Council's advice will assist the Minister in determining if the proposed amendment should be referred to the Fishermans Bend Standing Advisory Committee for further consideration.

## **6 INTERNAL REFERRALS**

### **6.1 City Design**

**Figure 24 – Comparison of Fisherman Bend Framework Plan layout compared to proposed layout**

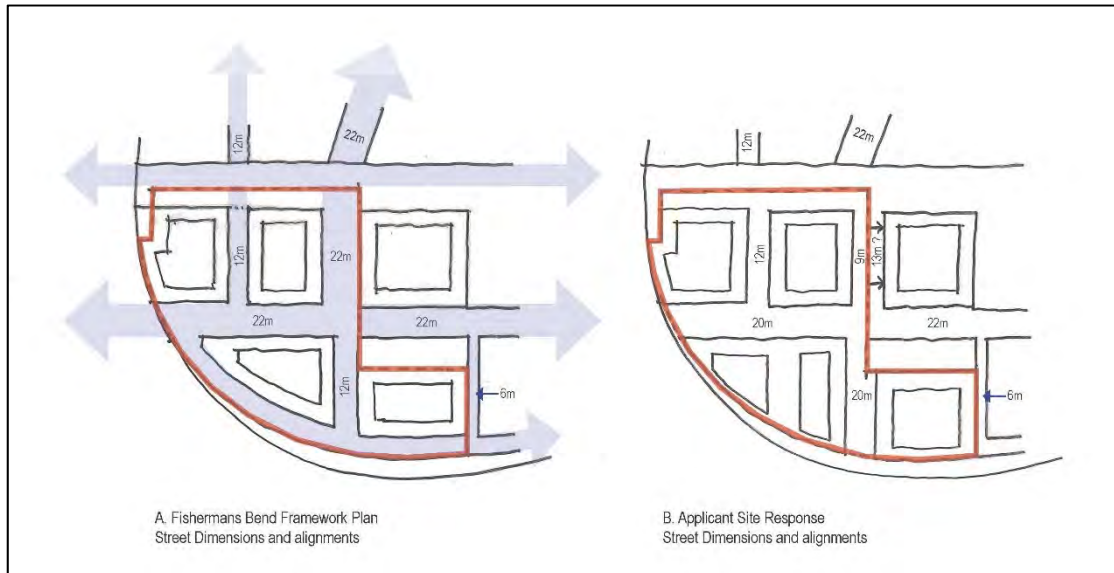
- The proposed development narrows the cross-section of the street from 22 metres to 20 metres. There is concern with the reduced cross section as well as its proposed configuration. For example the Framework anticipates it as a future public road and therefore should be unencumbered from private structures such as ramps and bicycle parking. Furthermore the cross section only appears to have a footpath on the southern side of the street rather than on both sides.

- The 22 metre public road reserve needs to continue unencumbered to the western property boundary. The Framework Plan shows the undercroft of the Bolte Bridge being repurposed as public open space. This east-west street provides a crucial connection to this space.

- The full 22 metre cross section is needed as a public road reserve as it will serve not only movement functions, but also play important roles in urban ecology, mitigation of the urban heat island effect, water sensitive urban design and mitigation of flooding. It is also important for urban form legibility and coherence that the cross-section is a consistent 22 m width across this site and all other development sites that include this road.

- The Framework Plan shows this area as a 12 metre road reserve. Irrespective of whether it is open or closed to vehicles this area is considered to play an important role from a movement perspective and public space perspective. This area appears to operate more as a private space and as communal area for future users of the towers. It is also considered that further details are required on what the potential impacts may be from removing vehicles from this area.
- This area also appears encumbered by basement levels of car parking.

- It appears that this street has been shifted eastwards and the development is not delivering the full portion of the street width required by the Framework Plan. It should be delivered in accordance with the Framework Plan.

- The Framework shows a continuous 12 m public road reserve providing a role of both service access and separation of development from the West Gate Freeway. It is considered a greater separation should occur and that built form should also not overhang this area. The Framework Plan has this area shown with a 12 metre width which also assists in creating an openness to the sky.

- An amended Masterplan which more closely aligns with the road layout as shown in Schedule 67 of the Design and Development Overlay. For example the east-west road must be increased from 20 to 22 metres and free of any encumbrance. It is noted that the southern service road identified in the Fishermans Bend Framework was not included in the mapping detail associated with DDO67.

**Figure 25 – Tower shaping and height**

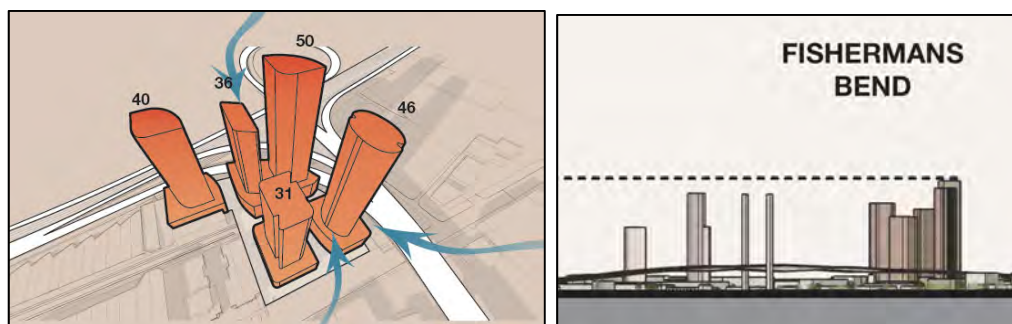
- The subject site is located within an area where hybrid, predominantly high-rise building typologies (16 storeys and taller) are encouraged with a built form that contributes to a varied and architecturally interesting skyline. The proposal at 31, 36, 40, 46 and 50 storeys, provides a height difference of 4-6 storeys. This is not considered to be a discernible height difference to achieve the desired variation in skyline. Particularly tower B and E are currently closely related in height, 50 and 46 storeys, which from various angles could be perceived as one volume. More height difference together with differentiated architecture / typology is required to achieve the varied built form outcome. Achieving an 8-10 storey height difference between towers is recommended.

- Recommend more height difference to the towers together with differentiated architecture / typology to achieve the varied built form outcomes.
- A façade strategy for each stage including material palette and design precepts, that detail the rationale and intent for the podium and tower forms.

Figure 28 – Implications of road layout on the proposed masterplan

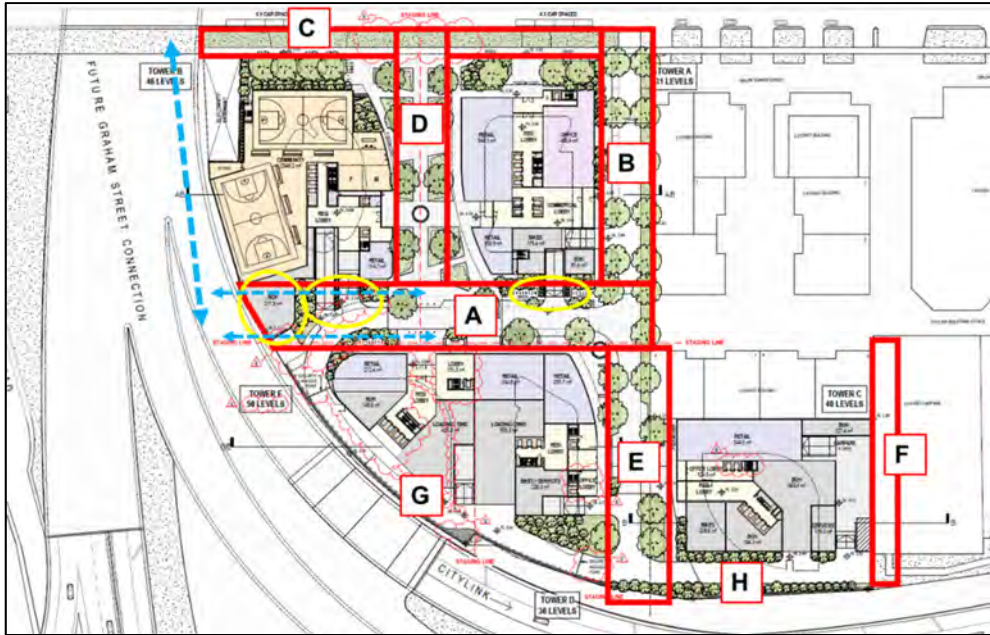
- The proposed masterplan is still not generally in accordance with Map 1 of Schedule 4 to Clause 37.04 nor the above Fishermans Bend - Definition Plan.

- An amended masterplan which increases the extent of non-residential floor space to 1.7:1 in accordance with Clause 22.27-4.1 of the Melbourne Planning Scheme.
- Show public road reserves, as per the assigned width, full length, and precise alignment outlined in Map 1 of Schedule 4 to Clause 37.04 of the Melbourne Planning Scheme and defined in further detail in "Fishermans Bend - Definition Plan, 162-188 Turner Street, Print Date: 7/12/2018". Specifically this includes:
  - An east-west 22 m wide public road reserve extending across the entirety of the property from eastern to western boundary, in full 22 m width for its entire length.
  - The western 11 m wide half of a north-south 22 m wide public road reserve straddling the boundary between 162-188 Turner Street and 190-206 Turner Street property, extending north

Figure 32 – Tower height variation

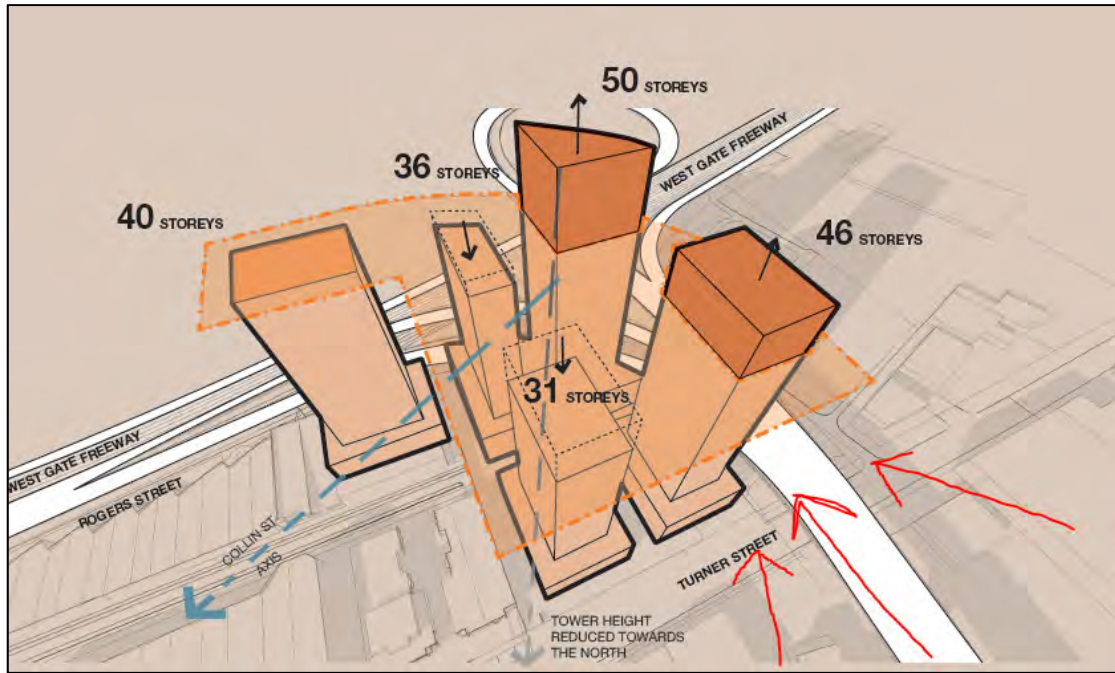
- The proposal at 31, 36, 40, 46 and 50 storeys, provides a height difference of 4-6 storeys. This is not considered to be discernible height difference to achieve the desired variation in skyline.
- Tower B and E are of concern as their height of 50 and 46 stories could be perceived as one volume particularly when viewed from the Bolte Bridge and Yarra River.

It is likely more height difference together with differentiated architecture / typology would achieve an improved outcome. Therefore an Officer recommendation includes a condition for achieving a minimum of 8 storey height difference between the towers without further increasing the height of any tower.
